Access Compliance Report

Public Rights-of-Way

(Curb Ramps)

Intersection ID: 10024493	Main Street: CROWNPOINT_EXECUTIVE_DR	Cross Street: N/A	Location: NW
ADA ID: 7717BF5332AE	Ramp Type: Perp	Initial Pass/Fail: Fail	Overall Compliance: No
Severity Score: 26.25			
Codes/Mitigation Info/Possible Solution		Field Measurements/Component Compliance

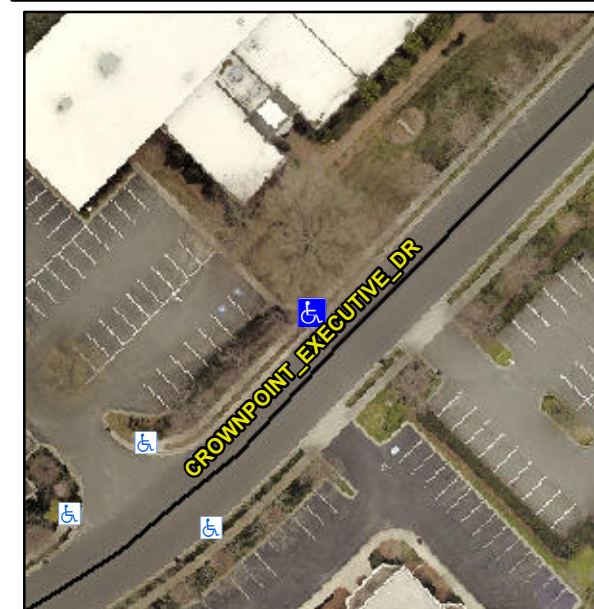
Not Found, R304.2.2, R304.5.3

Compliance	Description	Data	Compliance	Description	Data
N/A	Ramp Length (in)	46.0	No	Ramp Slope (%)	13.7
Yes	Ramp Width (in)	76.0	No	Ramp XSlope (%)	4.8
N/A	Flare Type LT	N/A	N/A	Flare Type RT	N/A
N/A	Flare Slope LT (%)	N/A	N/A	Flare Slope RT (%)	N/A
N/A	Flare Traversable LT?	N/A	N/A	Flare Traversable RT?	N/A
N/A	Landing Length (in)	N/A	N/A	DWS Provided?	N/A
N/A	Landing Width (in)	N/A	N/A	DWS Contrast?	N/A
N/A	Landing Slope (%)	N/A	N/A	DWS Length (in)	N/A
N/A	Landing X Slope (%)	N/A	N/A	DWS Full Width?	N/A
N/A	Landing Curb? (Y/N)	N/A	N/A	DWS Offset (in)	N/A
N/A	Shared Landing?	N/A			
N/A	Gutter Ponding?	N/A	N/A	Gutter Slope (%)	N/A
N/A	Gutter Lip Ht (in)	N/A	N/A	Gutter X Slope (%)	N/A
N/A	Painted X Walk1?	No	N/A	Painted X Walk2?	N/A
	X Walk 1 Direction	To SE		X Walk 2 Direction	N/A
N/A	X Walk 1 Width (in)	N/A	N/A	X Walk 2 Width (in)	N/A
	X Walk 1 Slope (%)	3.1		X Walk 2 Slope (%)	N/A
	X Walk 1 X Slope (%)	3.5		X Walk 2 X Slope (%)	N/A

Remove & Replace Entire Ramp.
